# Access Compliance Report

## Public Rights-of-Way

Intersection ID: 7375	Main Street: TRYON_ST	Cross Street: TOM_HUNTER_RD	Location: SE
ADA ID: 7AE7AA2EEC2A	Ramp Type: Directional1	Initial Pass/Fail: Pass	Overall Compliance: No
		Severity Score: 0

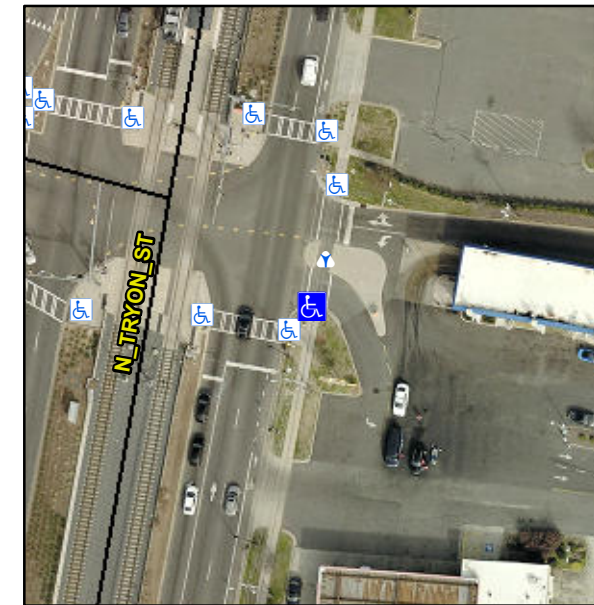
**R304.5.2, R305.2**

Compliance	Description	Data	Compliance	Description	Data
N/A	Ramp Length (in)	98.0	No	Grade Break?	No
Yes	Ramp Width (in)	68.0	N/A	Grade Break Slope (%)	N/A
Yes	Ramp Slope (%)	3.3	N/A	Grade Break XSlope (%)	N/A
Yes	Ramp XSlope (%)	2.0			
Yes	Flare Type LT	N/A	Yes	Flare Type RT	N/A
N/A	Flare Slope LT (%)	N/A	N/A	Flare Slope RT (%)	N/A
N/A	Flare Traversable LT?	No	N/A	Flare Traversable RT?	No
Yes	Landing Length (in)	48.0	Yes	DWS Provided?	Yes
Yes	Landing Width (in)	71.0	Yes	DWS Contrast?	Yes
Yes	Landing Slope (%)	0.6	Yes	DWS Length (in)	24.0
Yes	Landing X Slope (%)	2.0	Yes	DWS Full Width?	Yes
N/A	Landing Curb? (Y/N)	N/A	No	DWS Offset LT (in)	3.0
N/A	Shared Landing?	Yes	Yes	DWS Offset RT (in)	3.0
Yes	Gutter Ponding?	No	Yes	Gutter Slope (%)	1.0
Yes	Gutter Lip Ht (in)	0.0	Yes	Gutter X Slope (%)	0.5
N/A	Painted X Walk1?	Yes		Road Slope (%)	1.8
	X Walk 1 Direction	To N		Road X Slope (%)	2.8
	X Walk 1 Width (in)	120.0		Clear Space?	Yes

**Remove & Replace Entire Ramp.**
